PCN Number: 1604-2 Chgnot.doc rev. ___ 2/16

Product/Process Change Notification (PCN)

Date: 24 August 2016

Legacy UA vs Matrix HD UA - Visual Differences

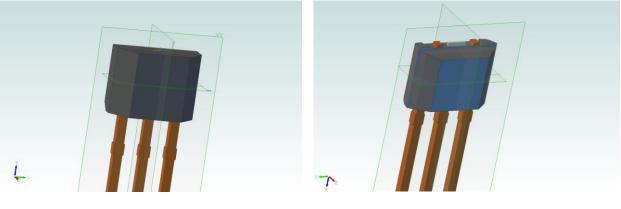
• Top of package on the Matrix HD UA has tie and dam bar protrusions

Legacy UA

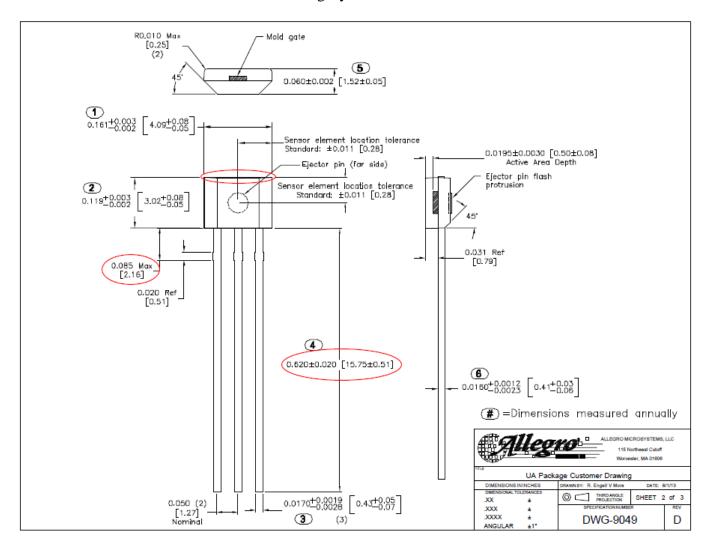
Mold Compound: MG35F Package lead length: 15.75 +/- 0.51 mm Lead Finish: Trim after tin plate Dam bar from package: 2.16 mm Mold gate top of the package: None No Draft Angle from Top Mold to back of package

Legacy UA vs Matrix HD UA – Dimensional Comparison

Matrix HD UA

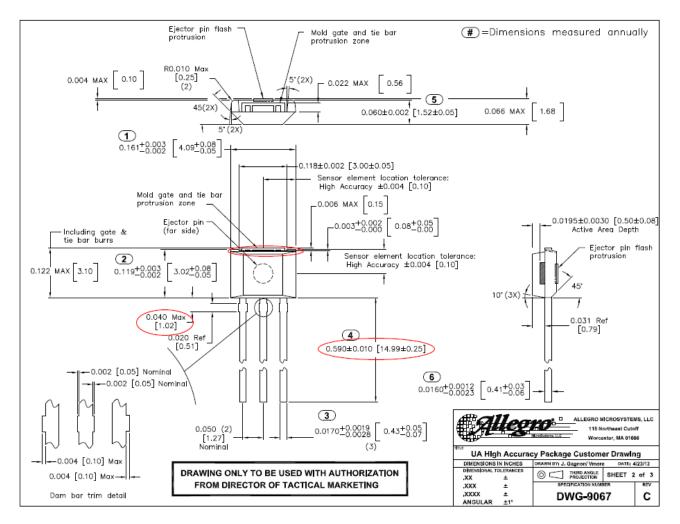
Legacy UA vs Matrix HD UA – Dimensional Comparison Continued

Package	Width (mm)	Height (including tie & gate bar protrusions) (mm)	Lead Length (mm)	Leadframe Mold Offset (mm)
Legacy UA	4.09 (+0.08, -0.05)	3.02 (+0.08, -0.05)	15.75 +/-0.51	+/-0.101
Matrix HD UA	4.09 (+0.08, -0.05)	3.02 (+0.08, -0.05)	14.99 +/-0.25	+/-0.051

Mold Compound: G700-LS, Rohs compliant low stress, green mold compound Package lead length: 14.99 +/- 0.25 mm

Lead Finish: Trim before Tin plate resulting in plating of the dambar with no exposed Cu in this area

Dam bar from package: 1.02 mm

Mold gate top of the package: The redesigned with mold "pull-backs" in the gate and tie bar areas prevent mold flashing and burrs from protruding beyond the gate and tie bars. 10° Draft Angle from Top Mold to back of package: Improve with the mold ejection during prob.
